## IDAP REPORT

<b>Property:</b>	56 Pemberton Street STRATHFIELD Lot: 124 DP: 15955 DA2022.112
<b>Proposal:</b>	Demolition of existing structures and construction of a two storey dwelling with basement garage and swimming pool.
<b>Applicant:</b>	J Ah-Ching
<b>Owner:</b>	S.Taneja
<b>Date of lodgement:</b>	23 June 2022
<b>Notification period:</b>	28 June 2022 - 12 July 2022
<b>Submissions received:</b>	Nil
<b>Assessment officer:</b>	L Gibson
<b>Estimated cost of works:</b>	\$2,065,011.00
<b>Zoning:</b>	R2-Low Density Residential - SLEP 2012
<b>Heritage:</b>	No
<b>Flood affected:</b>	Yes
<b>Is a Clause 4.6 Variation Proposed:</b>	N/A
<b>RECOMMENDATION OF OFFICER:</b>	<b>REFUSAL</b>

*Figure 12: Indicative streetscape elevation plan*

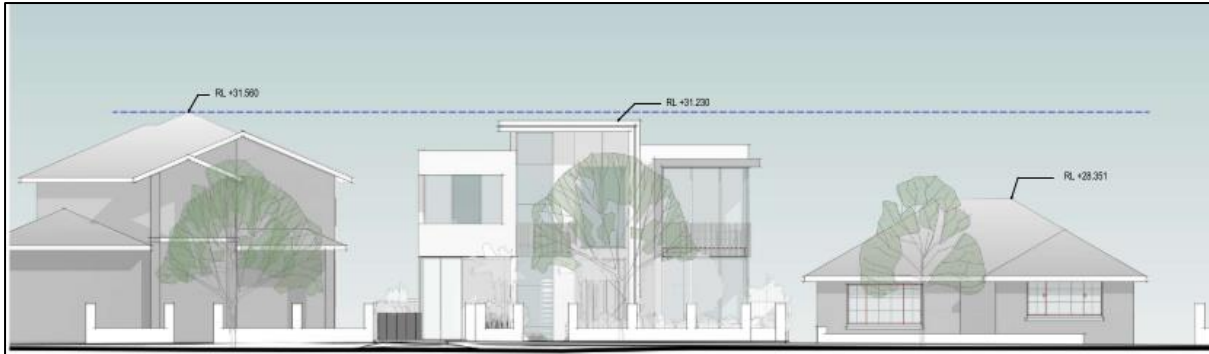
The proposal seeks a modern and flat roofed design. Whilst a modern design may be considered within the streetscape, the design fails to incorporate a similar bulk and scale that complements the prevailing development in the streetscape as required by Section 2 of Part A of the SCDP 2005. The proposal seeks large expanses of glazing to the façade which is further accentuated by the blade wall which extends up through the façade and continues across the roof line which forms the parapet. The proposal consequently results in a building height of 8.48m, which exceeds the maximum permitted 7.8m building height as per Section 4.2.2 of Part A of the SCDP 2005.

In addition to the excessive voids, excessive height and lack of vertical articulation to the façade, the dwelling fails to achieve the minimum 20% combined setback requirements as per Section 4.2.3.1 of Part A of the SCDP 2005. The intent of these controls is to maintain view corridors between dwellings and achieve a sense of openness in the street.

Overall, the expansive height paired with the excessive bulk and scale proposed is considered excessive. This renders the development of being incompatible with both the prevailing and anticipated future development of the streetscape. The proposal is not supportable in this regard.

Figure 13: 9AM shadow diagrams (Winter Solstice)

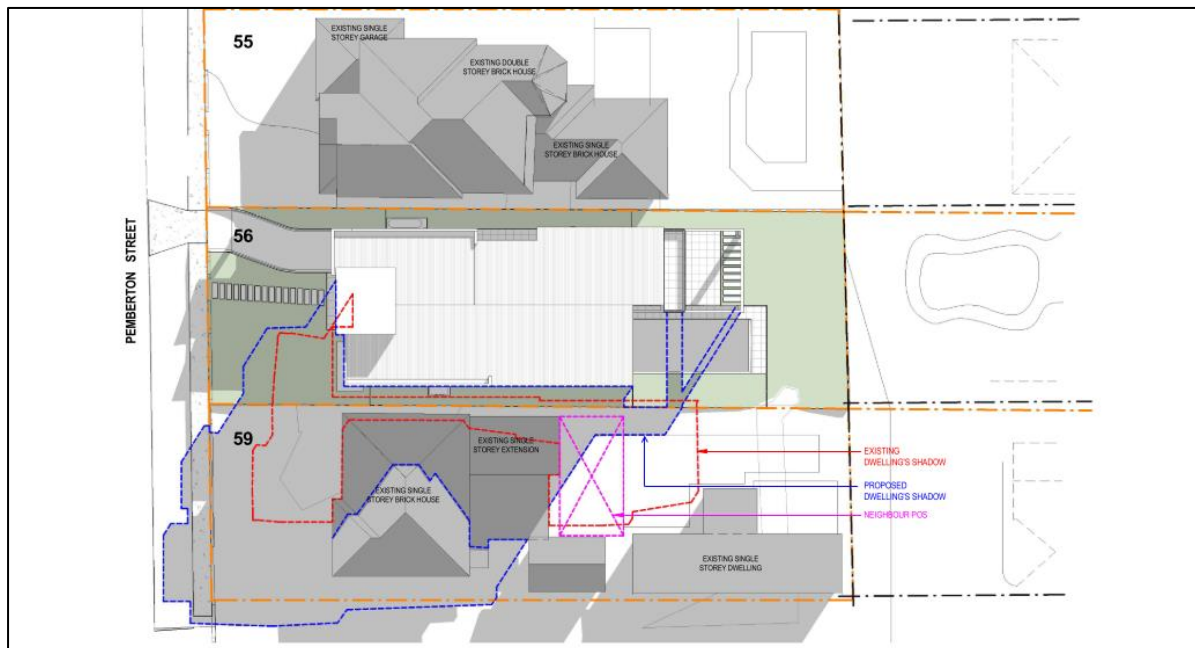
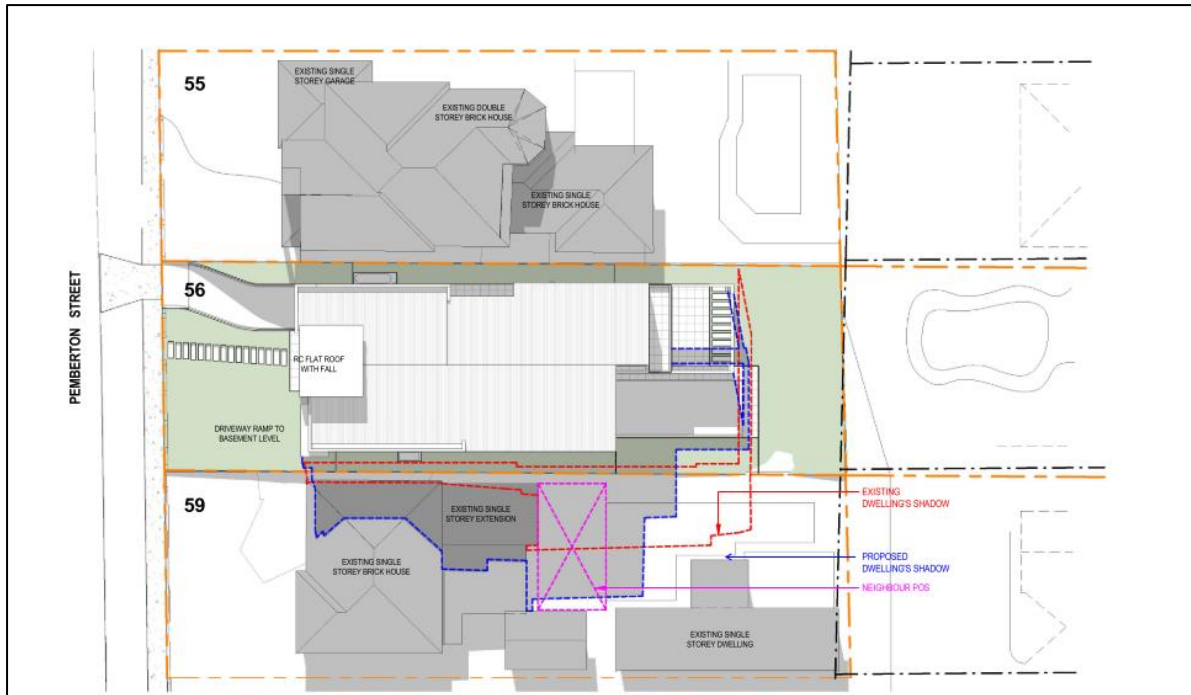
The dwelling provides an east-west orientation resulting in an unavoidable degree of overshadowing to the south. The proposal results in overshadowing to the south resulting in a further loss of solar access to the windows and private open space area of the southern adjoining property. This is contrary to Section 6.2.1 of Part A of the SCDP 2005.

The southern adjoining dwelling at 58 Pemberton Street is provided with a number of north-facing windows to its northern side elevation. The proposed development would inevitably result in additional shadows cast over the southern adjoining neighbour including to these northerly windows (refer to Figures 13, 14 and 15 below for reference).

Further analysis could have been prepared and submitted to Council to demonstrate the degree of impact to the southern adjoining dwelling. As previously discussed, the elongated building footprint is attributed by its excessive floor space and voids all of which result in additional overshadowing impacts to the southern adjoining resident. Whilst it is acknowledged that the proposal will inevitably result in additional overshadowing impacts, there is considerable opportunity to reduce the overshadowing impact to the southern adjoining resident through adopting a more considered design approach. This should include deletion of voids, achieving a compliant floor space and reduction in the building footprint to what is currently proposed. The proposal is therefore unable to be supported in this regard.
